Enclosure 4

Edwin I. Hatch Nuclear Plant
Response to Second RFAI
Power Uprate Submittal

Page Change Instructions

Figure 3.4.1-1 (Page 1 of 1)
Power-Flow Operating Map with One Reactor
Coolant System Recirculation Loop in Operation

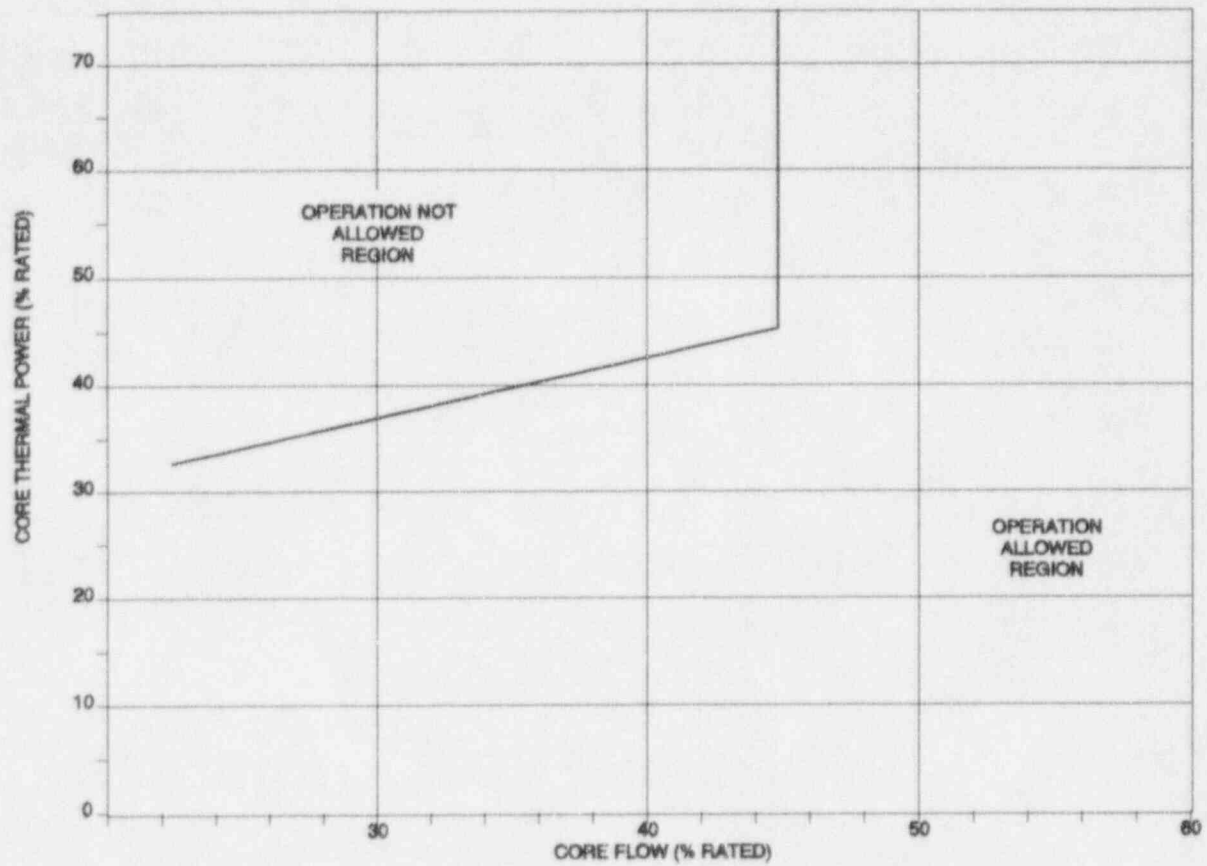
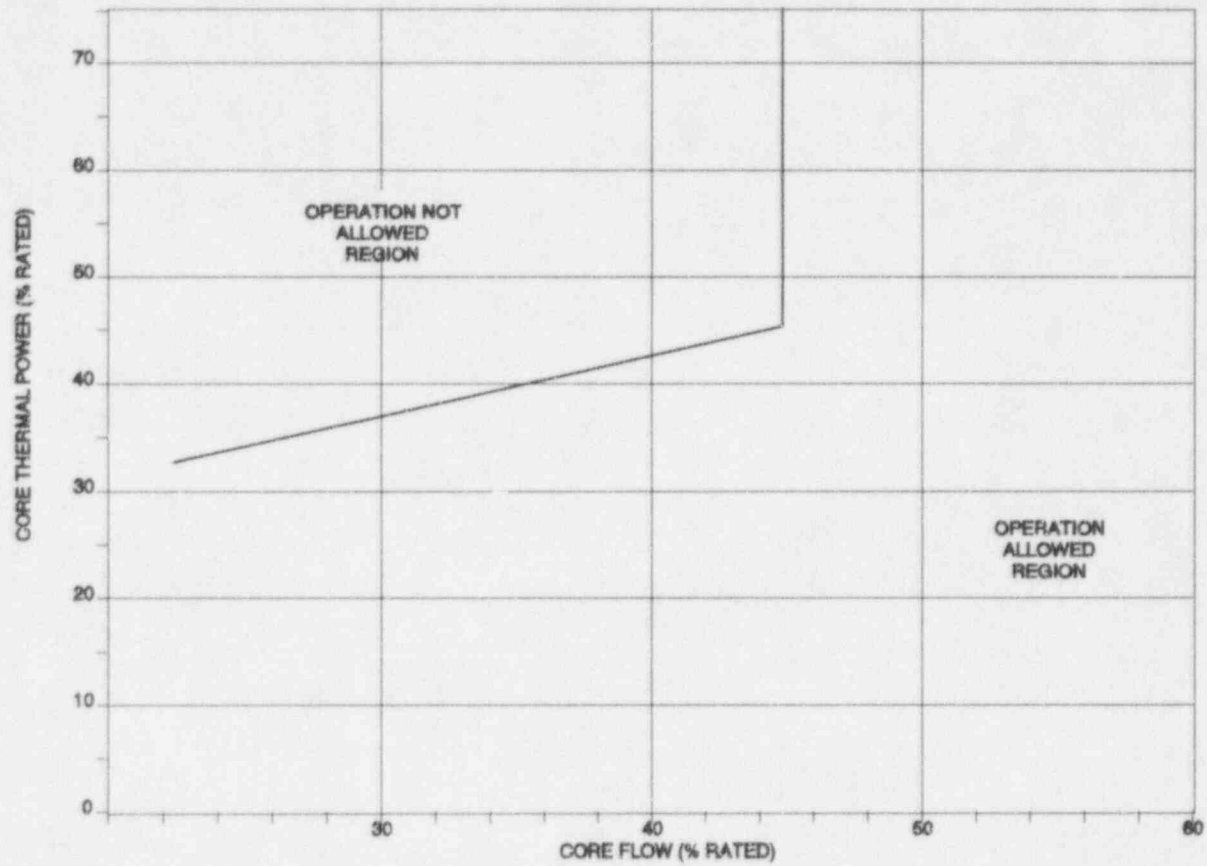
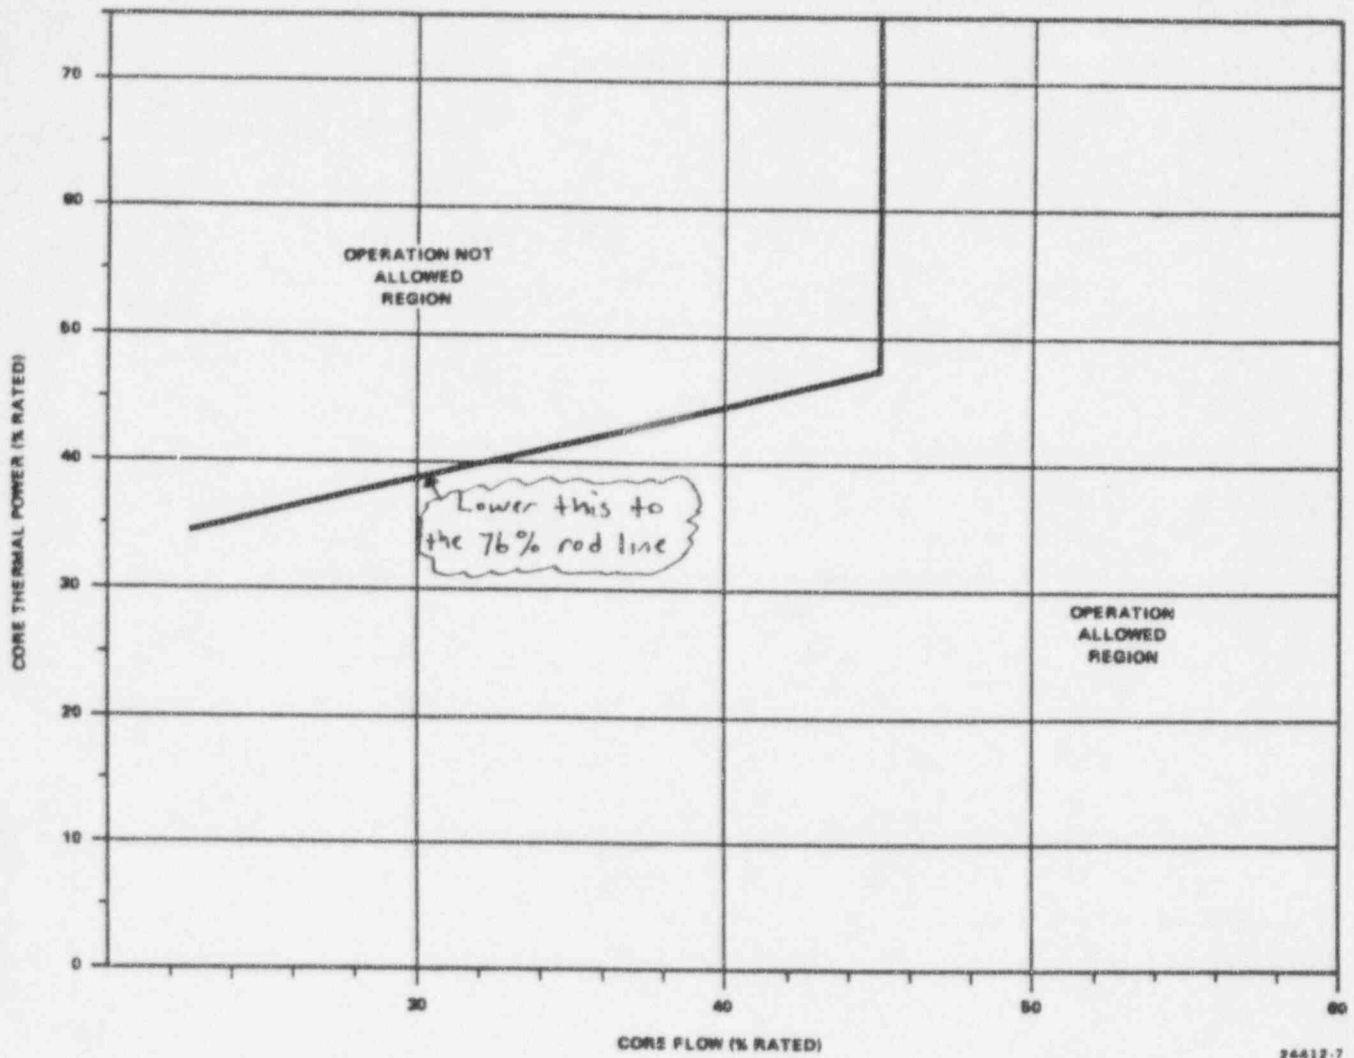
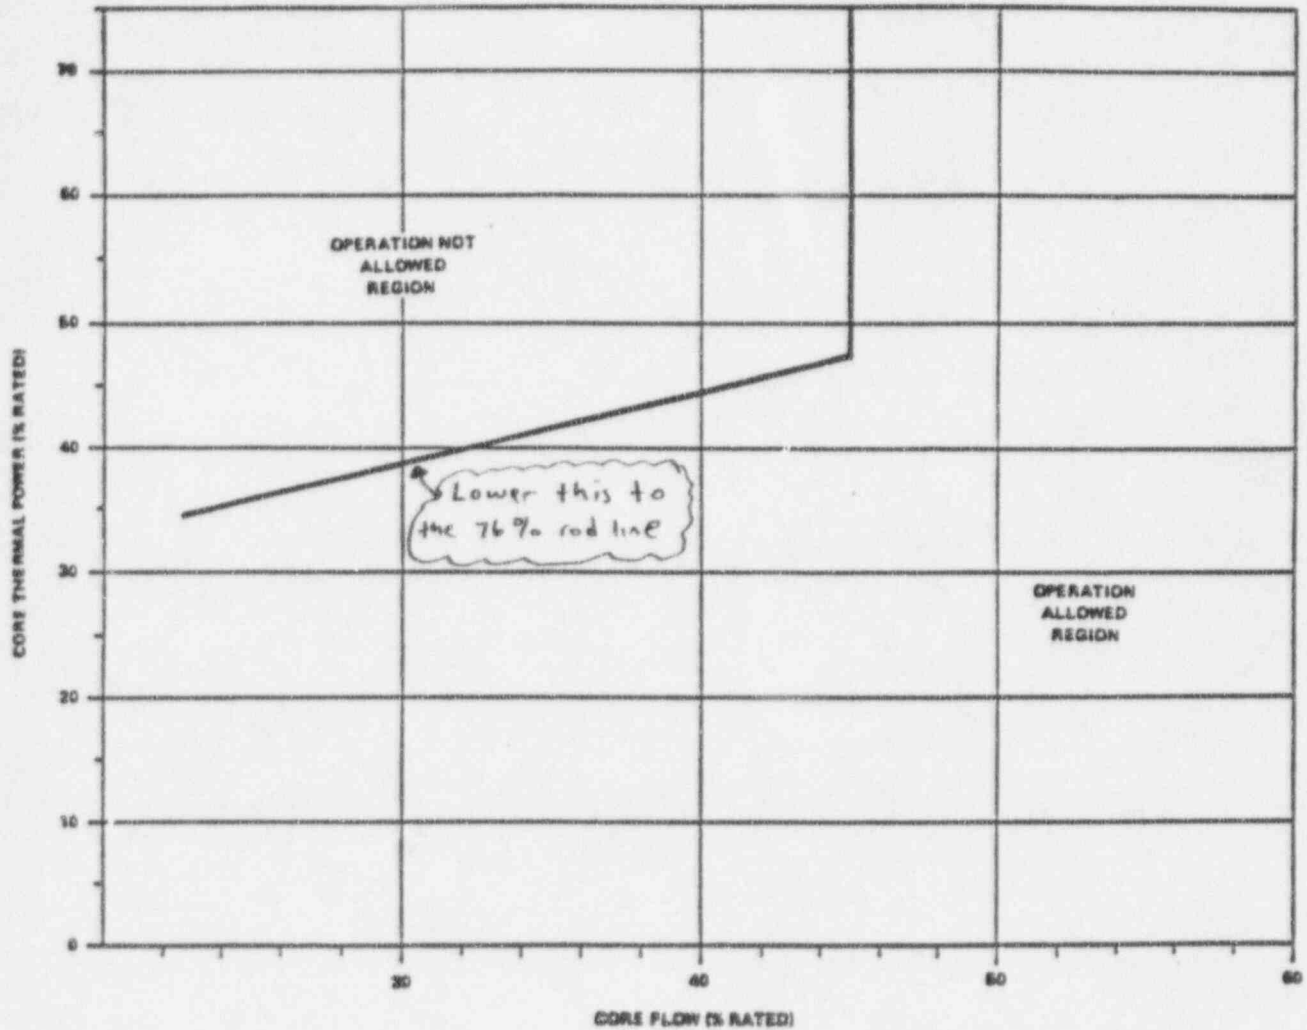
LCO (continued)	and APRM Flow Biased Simulated Thermal Power — High setpoint (LCO 3.3.1.1) must be applied to allow continued operation consistent with the assumptions of Reference 3. In addition, core flow as a function of core thermal power must be in the "Operation Allowed Region" of Figure 3.4.1-1 to ensure core thermal-hydraulic oscillations do not occur.
--------------------	--

ACTIONS	<p><u>A.1 and B.1</u></p> <p>Due to thermal-hydraulic stability concerns, operation of the plant with one recirculation loop is controlled by restricting the core flow to $\geq 45\%$ of rated core flow when THERMAL POWER is greater than the 76% rod line. This requirement is based on the recommendations contained in GE SIL-380, Revision 1 (Reference 4), which defines the region where the limit cycle oscillations are more likely to occur. If the core flow as a function of core thermal power is in the "Operation Not Allowed Region" of Figure 3.4.1-1, prompt action should be initiated to restore the flow-power combination to within the Operation Allowed Region. The 2 hour Completion Time is based on the low probability of an accident occurring during this time period, on a reasonable time to complete the Required Action, and on frequent core monitoring by operators allowing core oscillations to be quickly detected. An immediate reactor scram is also required with no recirculation pumps in operation, since all forced circulation has been lost and the probability of thermal-hydraulic oscillations is greater.</p>

Due to thermal-hydraulic stability concerns, operation of the plant with one recirculation loop is controlled by restricting the core flow to $\geq 45\%$ of rated core flow when THERMAL POWER is greater than the ~~80%~~ rod line. This requirement is based on the recommendations contained in GE SIL-380, Revision 1 (Reference 4), which defines the region where the limit cycle oscillations are more likely to occur. If the core flow as a function of core thermal power is in the "Operation Not Allowed Region" of Figure 3.4.1-1, prompt action should be initiated to restore the flow-power combination to within the Operation Allowed Region. The 2 hour Completion Time is based on the low probability of an accident occurring during this time period, on a reasonable time to complete the Required Action, and on frequent core monitoring by operators allowing core oscillations to be quickly detected. An immediate reactor scram is also required with no recirculation pumps in operation, since all forced circulation has been lost and the probability of thermal-hydraulic oscillations is greater.
